#### 14.6 Metro West JDAP Application – (Lot 684) No. 135 Broadway, Nedlands – Serviced Apartment and cafe

### Form 1 – Responsible Authority Report (Regulation 12)

<b>Property Location:</b>	135 (Lot 684) Broadway, Nedlands
<b>Development Description:</b>	Mixed Use Development (26 Serviced Apartments and Café)
<b>DAP Name:</b>	Metro West Joint Development Assessment Panel
<b>Applicant:</b>	Ben Carter, Pinnacle Planning.
<b>Owner:</b>	Cedar Grove PTY LTD
<b>Value of Development:</b>	\$ 8 Million
<b>LG Reference:</b>	DA19-38621
<b>Responsible Authority:</b>	City of Nedlands
<b>Authorising Officer:</b>	Peter Mickleson
<b>DAP File No:</b>	DAP/19/01655
<b>Report Due Date:</b>	30 October 2019
<b>Application Received Date:</b>	14 August 2019
<b>Application Process Days:</b>	90 Days
<b>Attachment(s):</b>	<ul style="list-style-type: none"> <li>1: Location Plan</li> <li>2: Development Plans and Elevations</li> <li>3: Applicant’s Planning Report</li> <li>4: Traffic Impact Assessment</li> <li>5: Landscaping Plan</li> <li>6: Acoustic Report</li> <li>7: Waste Management Plan</li> <li>8: City’s Assessment against SPP 7.0</li> <li>9: City’s Assessment against SPP 7.3 (to be finalised)</li> <li>1

Figure 1 – illustration of streetscape character for the different density codes.

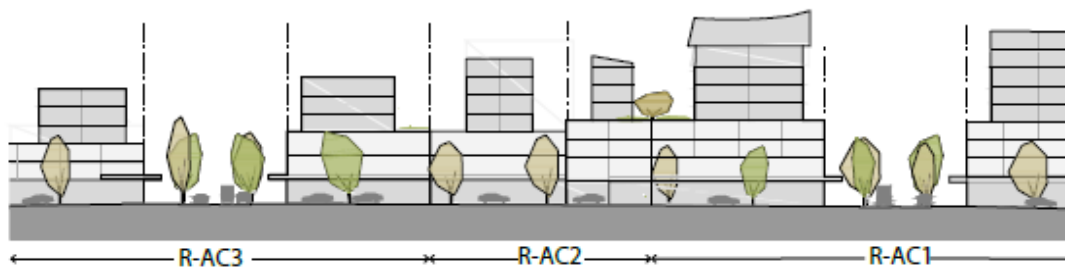
Regarding the desired streetscape character, in the absence of an adopted policy framework specific to the Broadway precinct, the City must defer to the streetscape character illustrated and described in Appendix 2 of the R-Codes Volume 2, and consider the submissions received which overwhelmingly requested a more detached form of development, with increased setback from the side boundaries. Considering the above, the development does not achieve this element objective.

ROOFTOP TERRACE (LEVEL 6)  
scale 1:200@A2

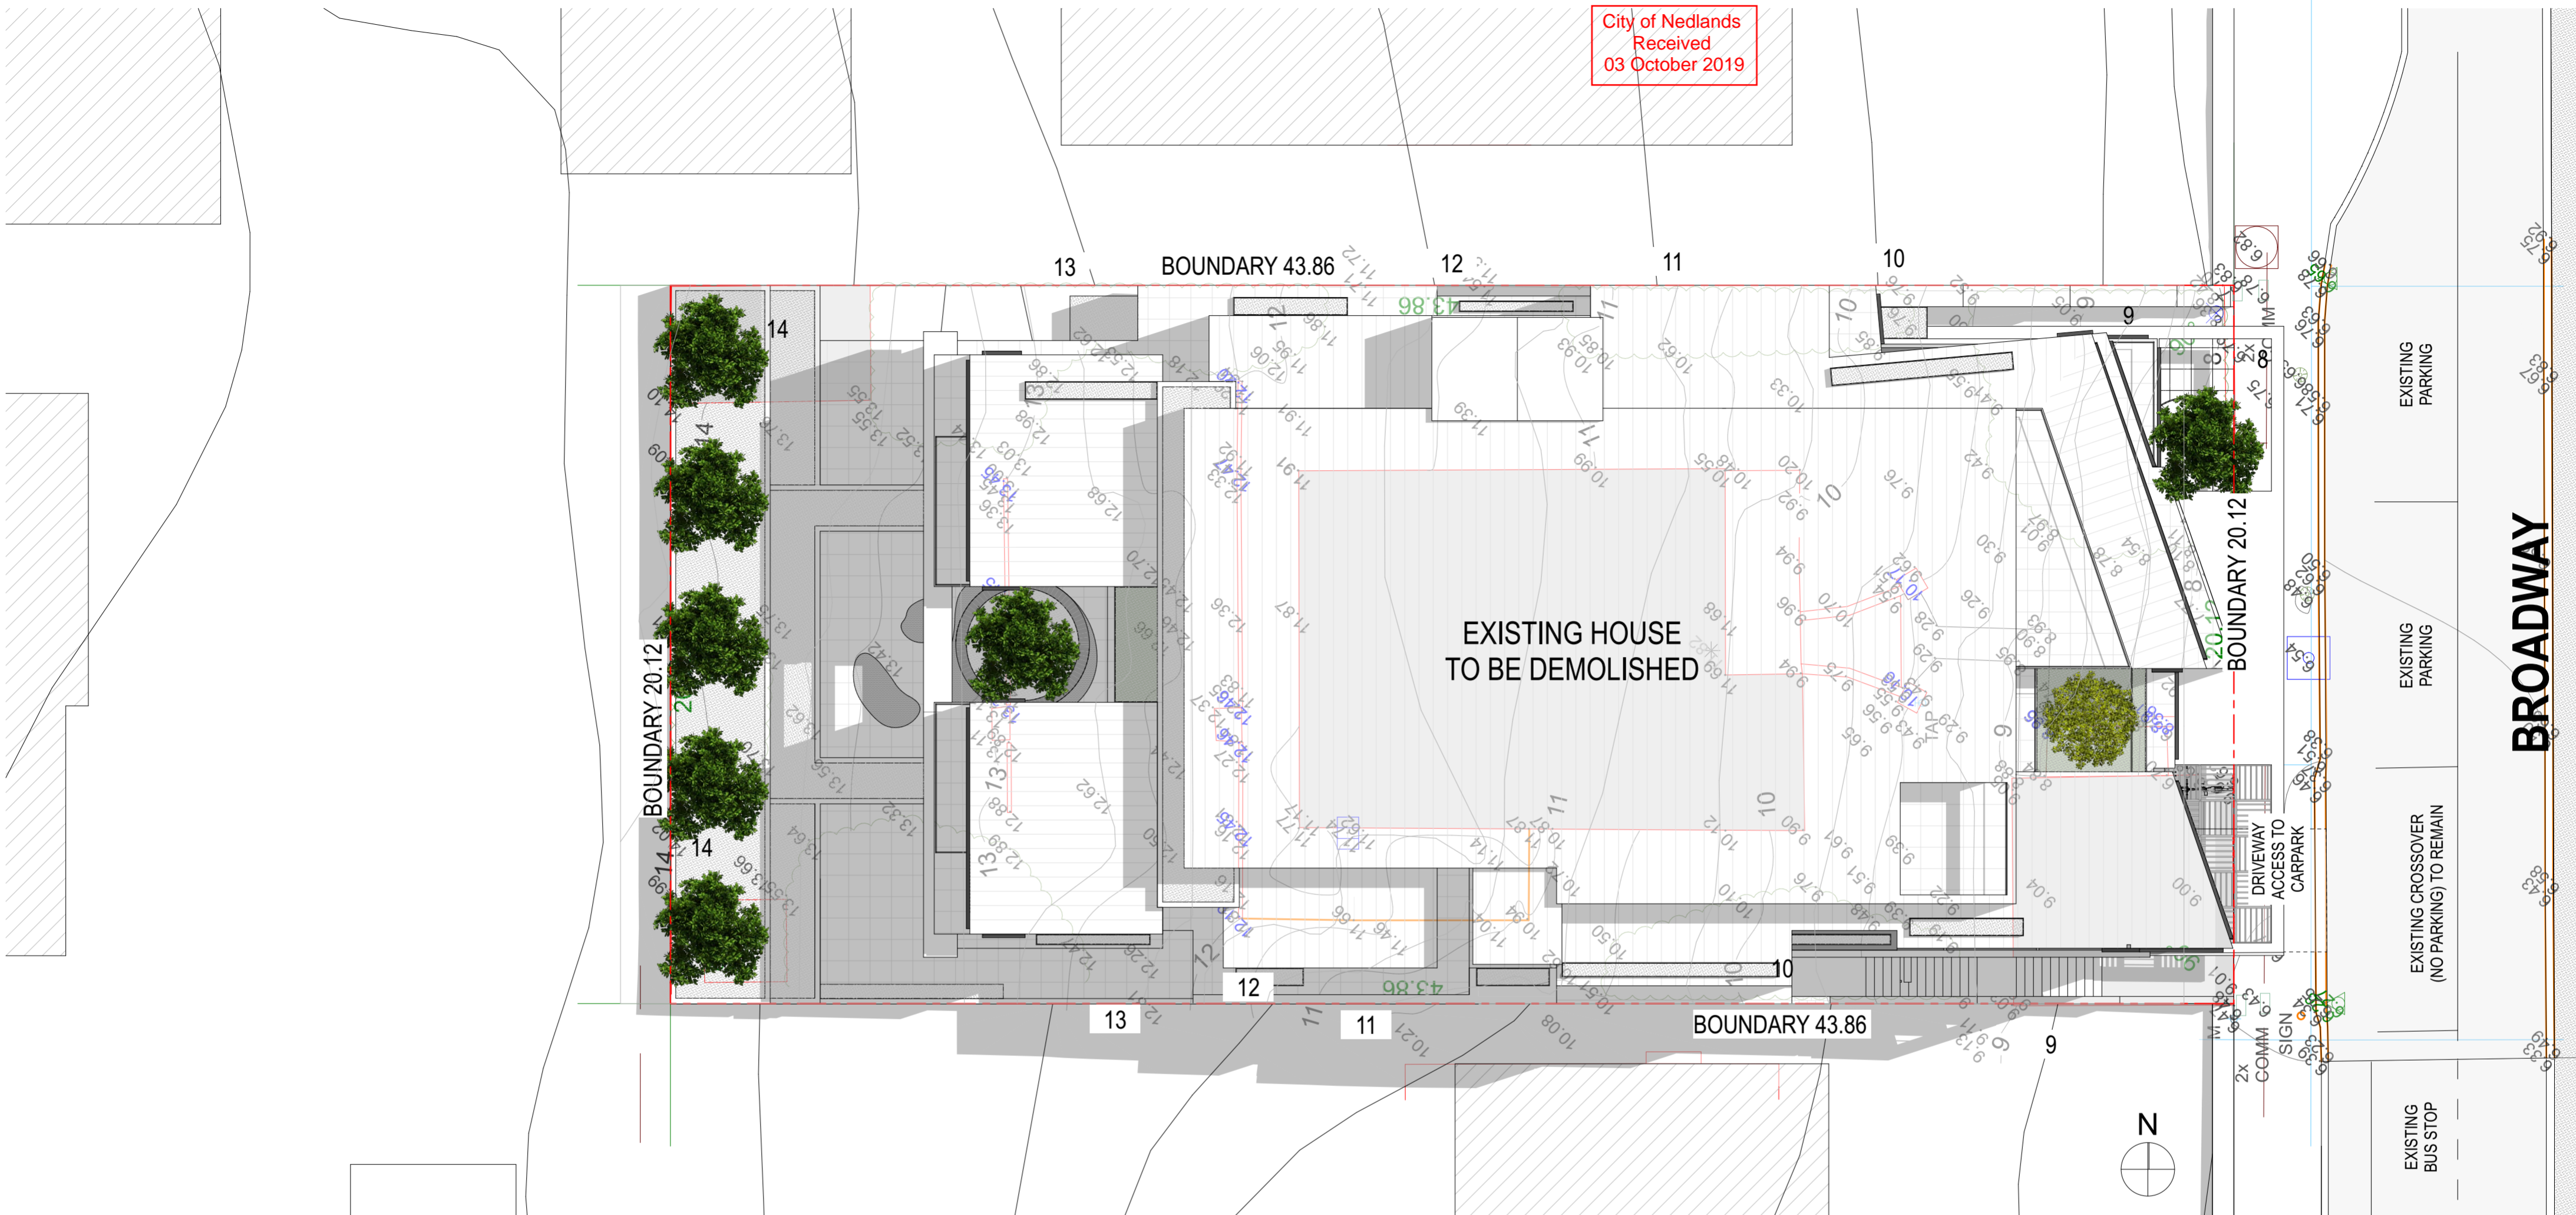
- 2. The roof top in its current location may present disturbance to residential properties to the west. Applicant should relocate the roof away terrace from the current location or accept a condition that the roof top cannot be used beyond 9PM (Note: City to nominated hours of use).*

The applicant modified the plans by relocating the roof terrace to the front of the building, thereby addressing the above recommendation.
